**REGULAR MEETING OF THE THIRD LAGUNA HILLS MUTUAL
ARCHITECTURAL CONTROL AND STANDARDS COMMITTEE**

**Monday, February 26, 2018 – 9:30 a.m.
Laguna Woods Village Community Center Sycamore Room
24351 El Toro Road**

DATE: February 26, 2018
FOR: Architectural Control and Standards Committee
SUBJECT: Variance Request
Mr. and Mrs. Richard and Heidi Penkava of 3191-D (La Reina, PL804RA)
Replace Existing Enclosed Rear Patio with Room Addition

EXISTING FLOOR PLAN

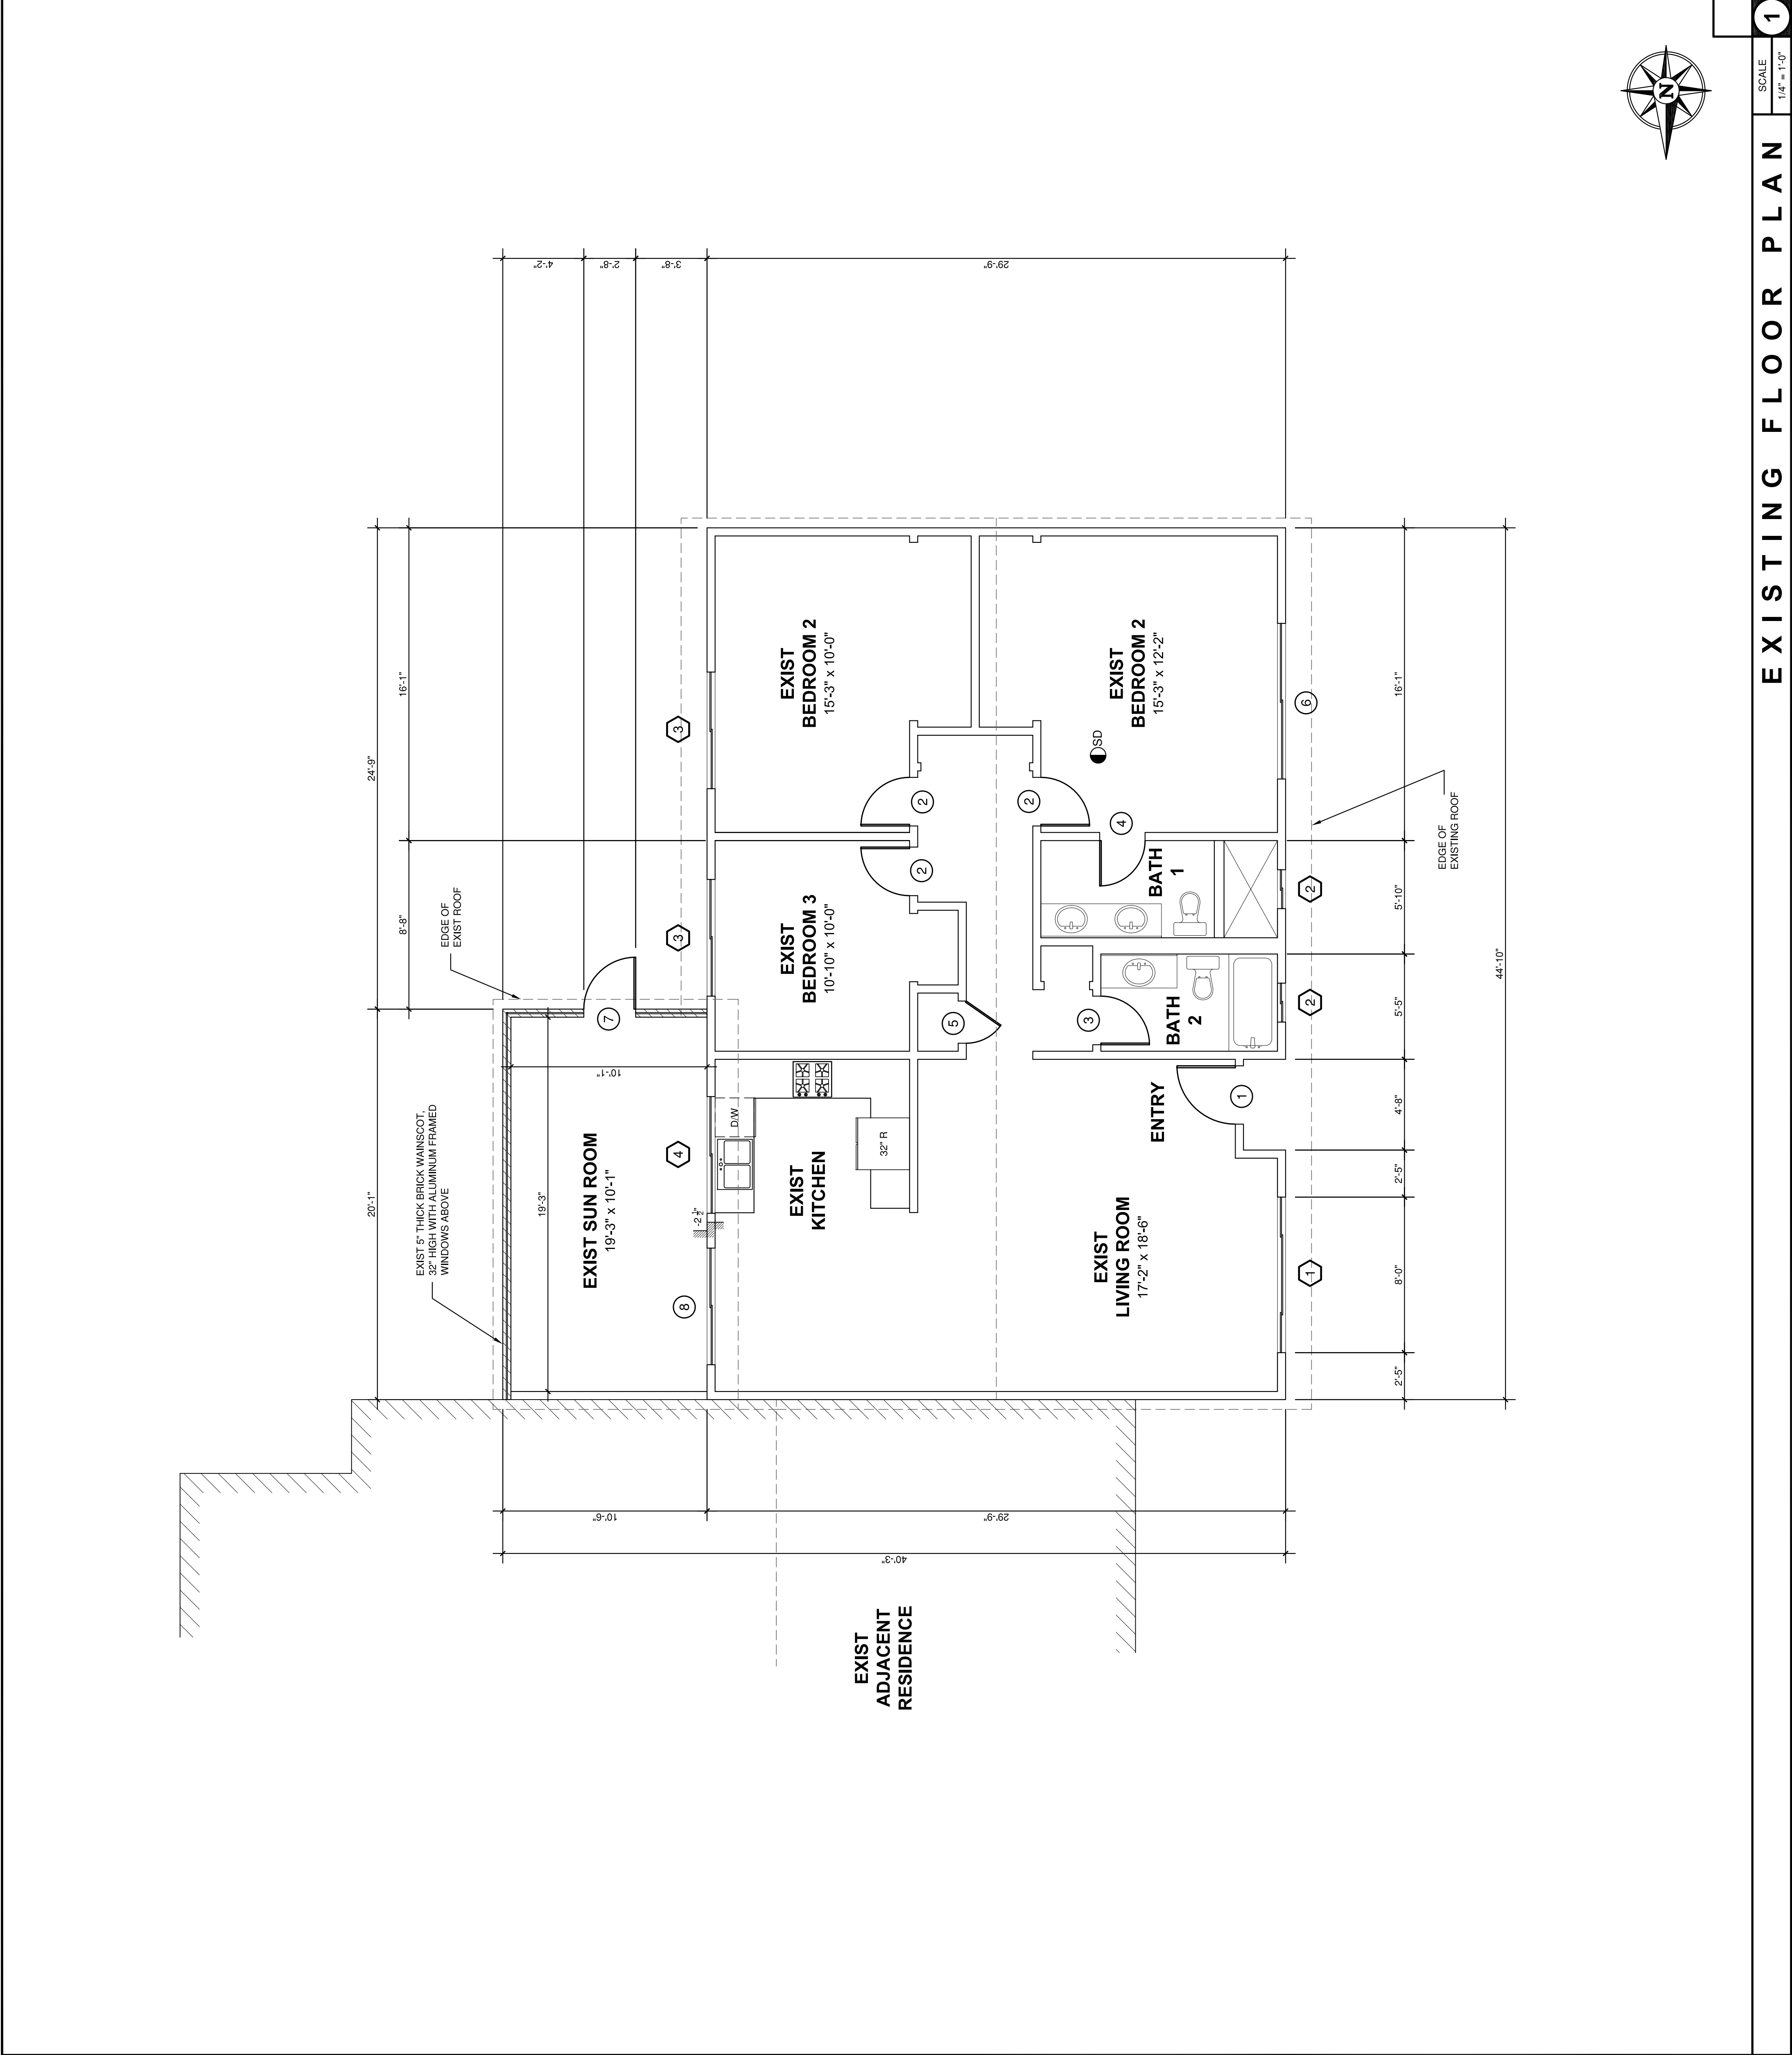
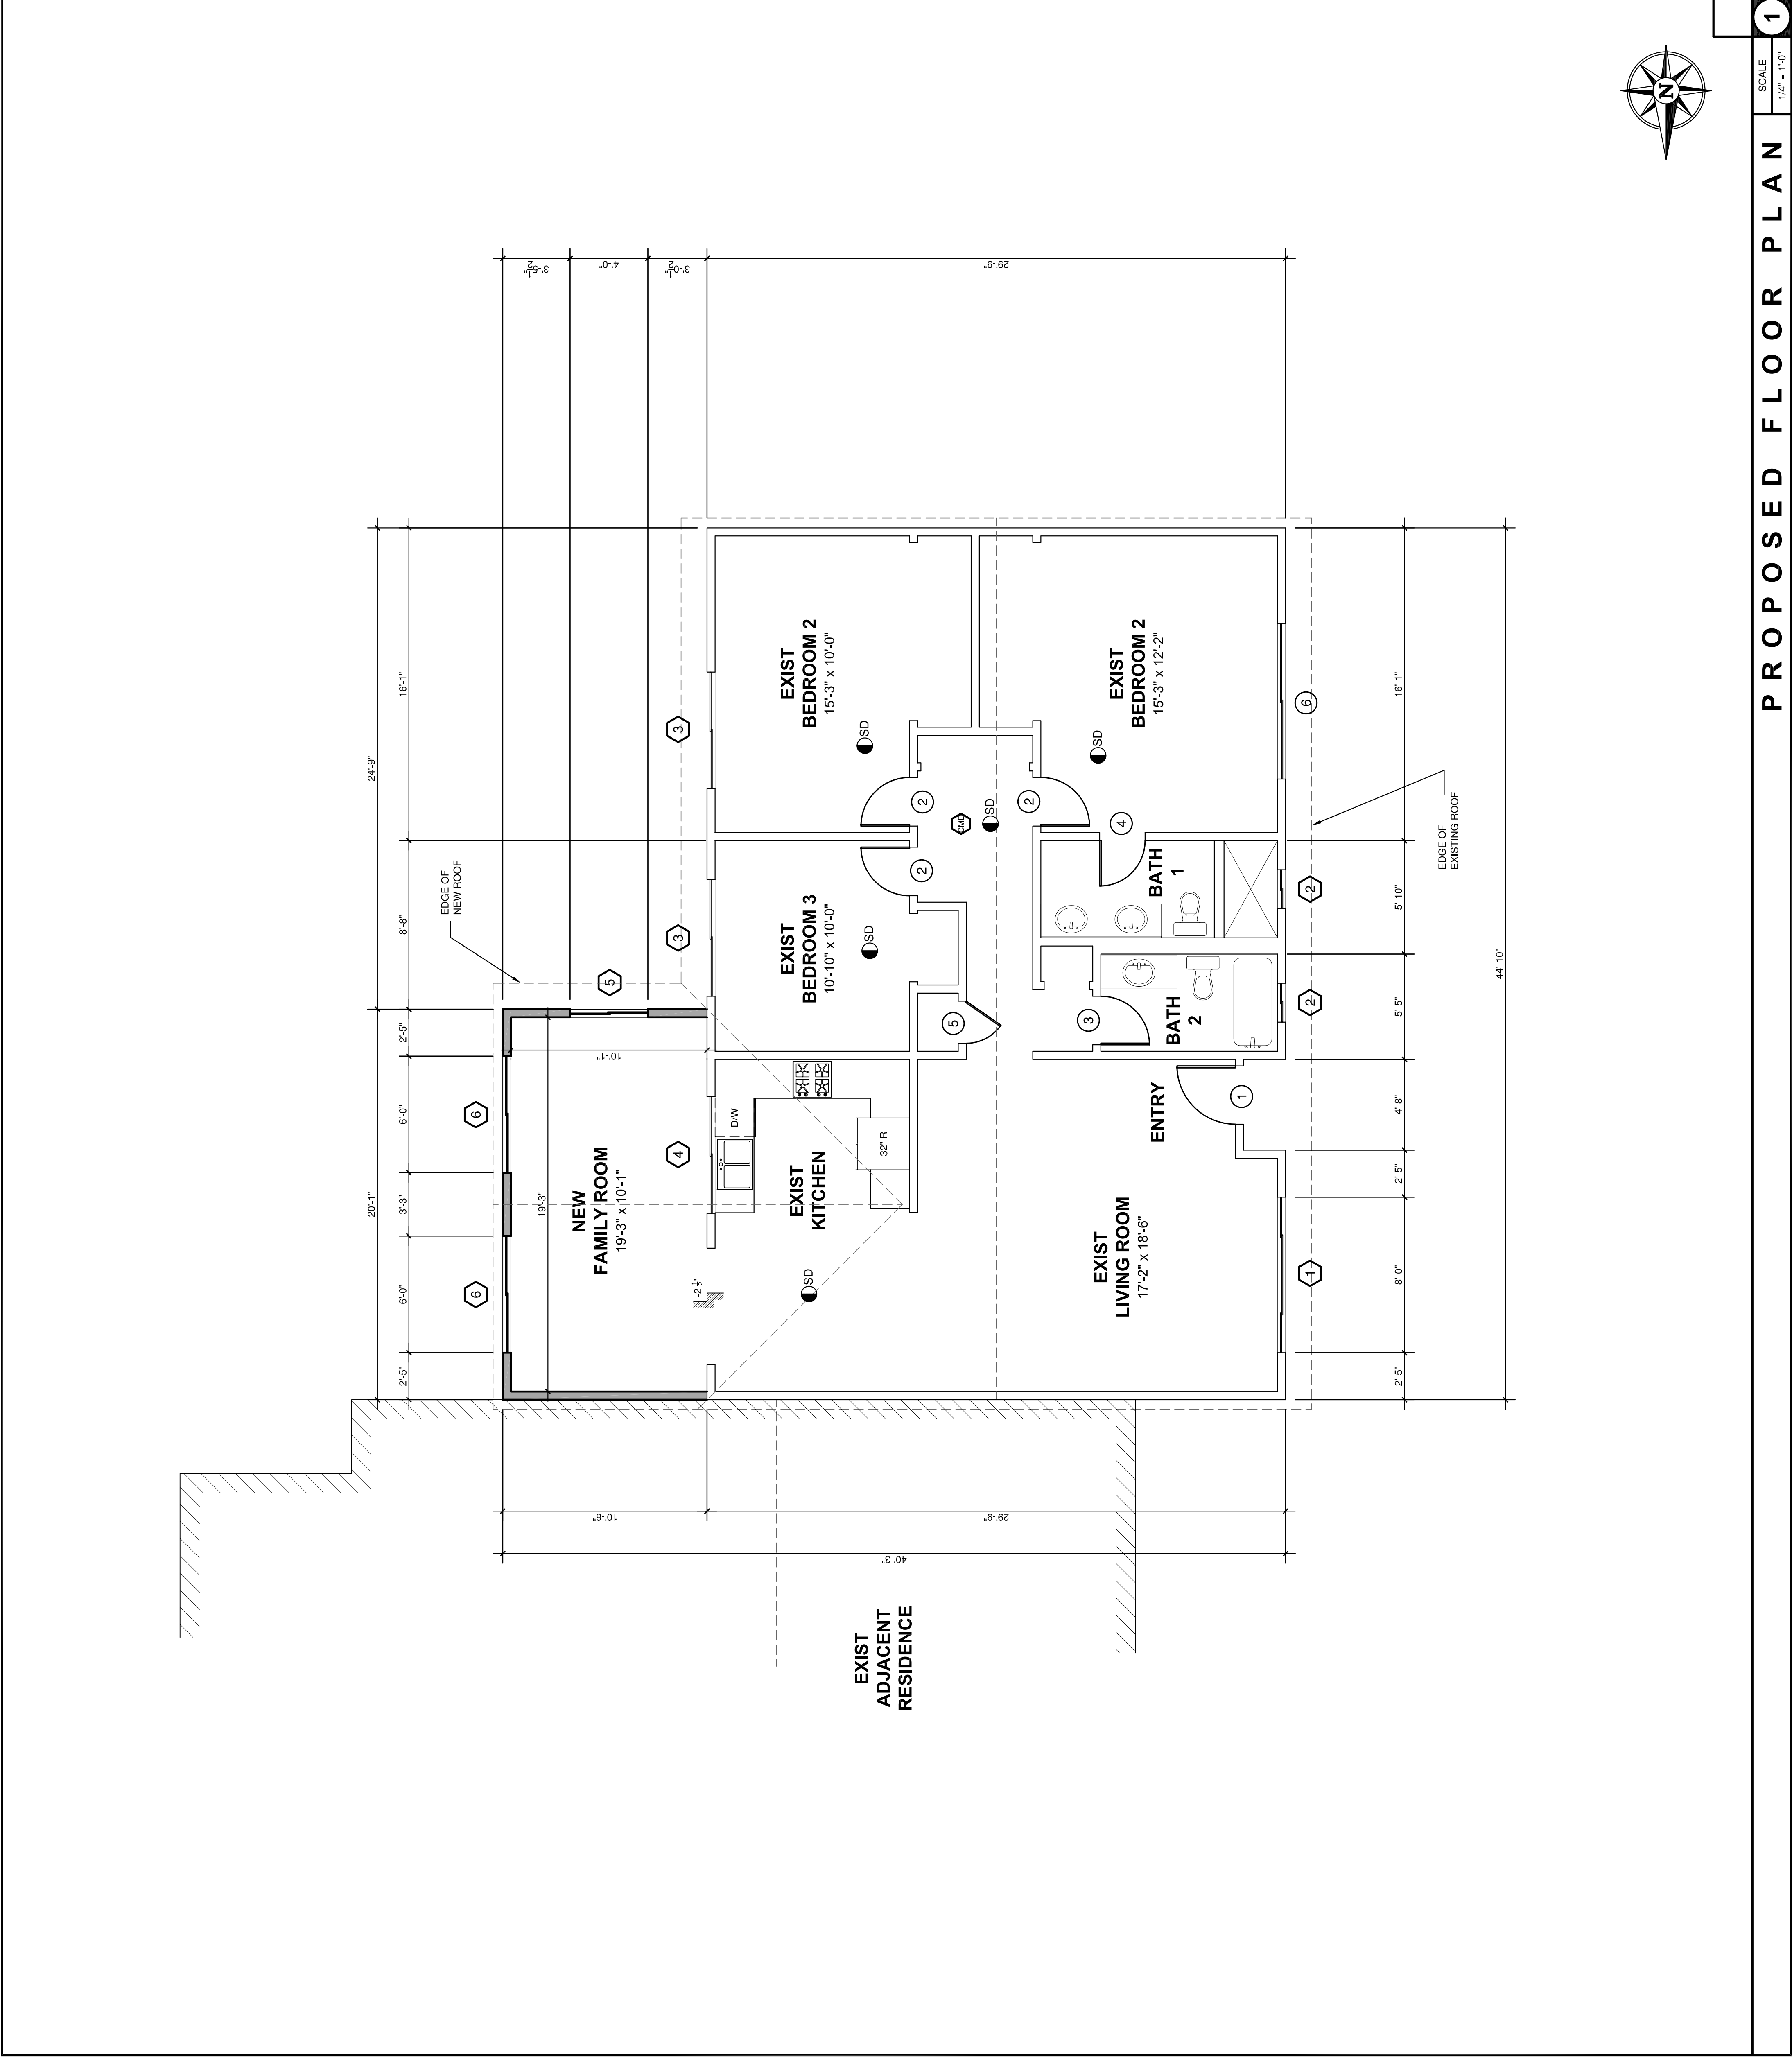
The original rear patio depicted on the condominium plan is 16 feet wide by 7 feet long. The existing patio measures 19 feet wide by 10 feet, 6 inches long, which is an increase of 87.5 square feet. There is no record of when the patio was extended. As mentioned above, a patio cover was installed in 1978. If the slab was extended at that time, it meets the criteria established in the Decision Tree. The records indicate that it was there when the existing glass windscreen was installed in 1993. If this variance is approved, a Common Area Agreement will be included in the Conditions of Approval.

The Penkavas' propose to demolish the existing windscreen enclosure and replace it with a room addition using wood frame construction with drywall and exterior stucco finish to match the existing building.

Acoustic considerations for common walls have been added to the conditions of approval (Appendix A).

1. A Mutual Consent for Manor Alterations has been granted at **3191-D** for **Rear Patio Room Addition**, subject to the attached plans stamped approved and is subject to the final inspection by the Division. Any variations to the approved attached plans are not allowed and could result in a stop work notice and/or severe fines to the Member.
